Serial No.: 10/065,516

For: METHOD OF DETECTING CRACKS IN JET
PUMP BEAMS OF A NUCLEAR REACTOR

REQUEST FOR APPROVAL OF DRAWING CHANGE

FIG. 6

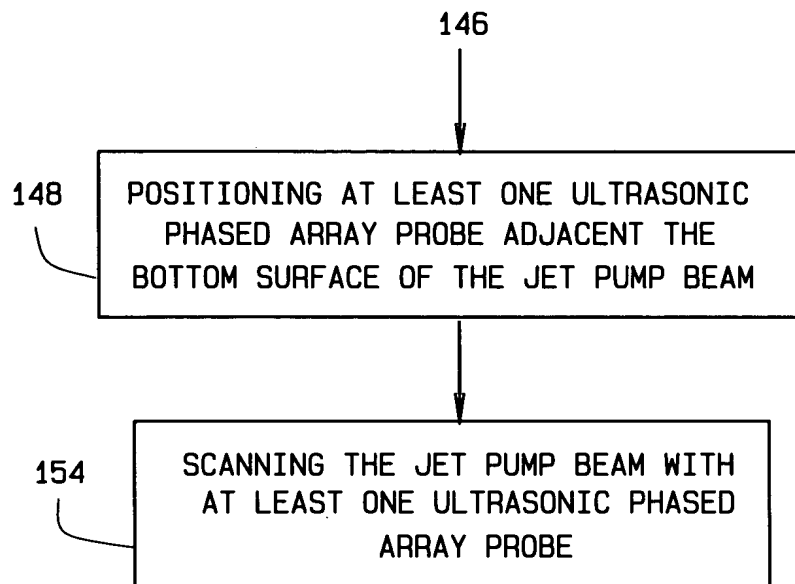
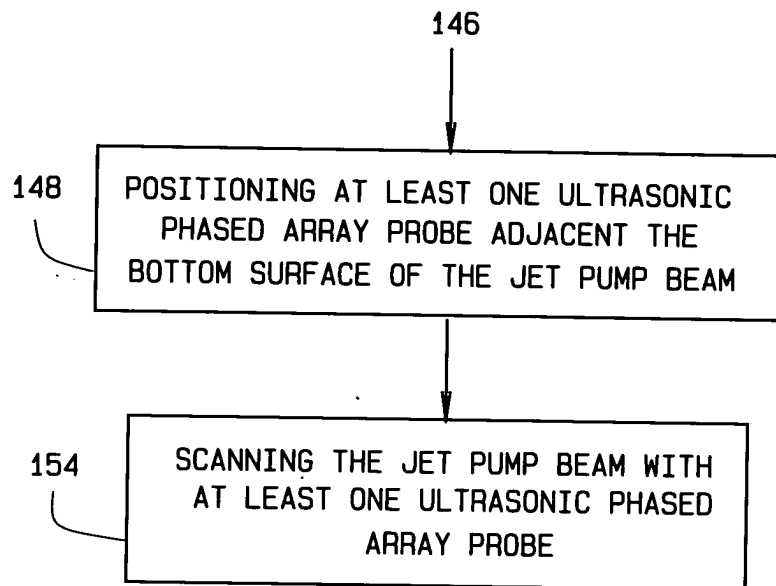
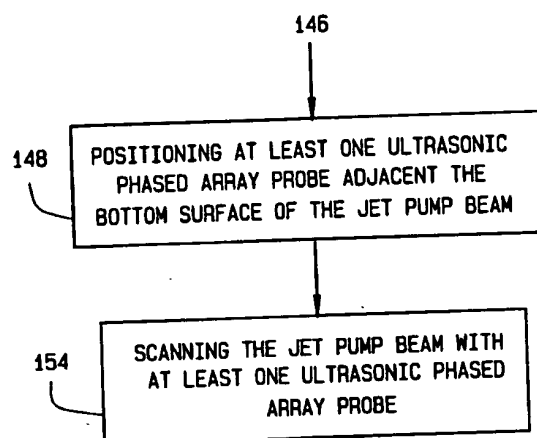
In response to the Notice To File Corrected Application Papers, submitted herewith are two (2) sheets of drawings showing changes to the labeling of the second Figure 5 and Figure 6 in the above referenced patent application. Specifically, the second Figure 5 has been relabeled as Figure 6, and the original Figure 6 has been relabeled Figure 7.
